**ANGEL PLACE
LEVEL 8, 123 PITT STREET
SYDNEY NSW 2000**

SECTION 4.55 (1A) APPLICATION TO AMEND SSD 104378- WATERLOO METRO QUARTER OSD BASEMENT DETAILED DESIGN

3. PROPOSED MODIFICATIONS

Approved Basement Level 00 Plan

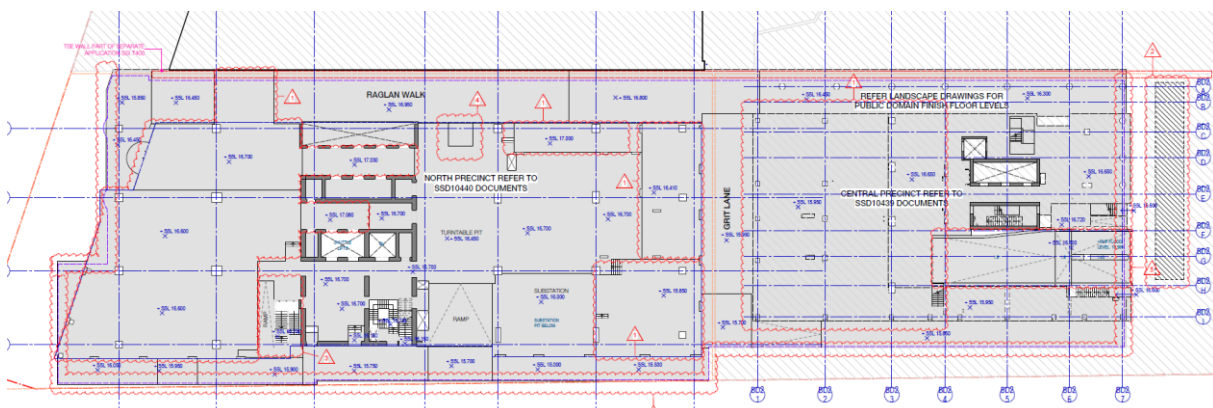
As part of the detailed design development (for construction), basement layout have been refined and reconfigured to accommodate servicing and engineering requirements, and most importantly to provide a safer arrangement for pedestrian and vehicle access within the basement. The approved number of car parking, motorbike parking, bicycle parking, and service bays remain unchanged.

- Reduction in excavation and footprint of the basement by approx. 200 m²/1400 m³.
- Refinement and reconfigure of services elements.
- Relocation of the End of Trip Facilities to align with the Northern and Central Precinct requirements,

- Introduce one way circulation aisles in the northern section of the car park on both levels.
- Consolidate the residential parking onto B1. Reconfigure the layout of car parking spaces to provide a more logical and efficiency basement layout.
- Slab levels on ground levels adjusted to suit the requirements of the flood analysis.
- OSD tank design has been further developed by the civil engineer, and coordinated with landscape to maximise deep soil in Church Square. This has resulted in the change to the footprint of the OST tank. The OST tank can continue to comply with stormwater requirement.
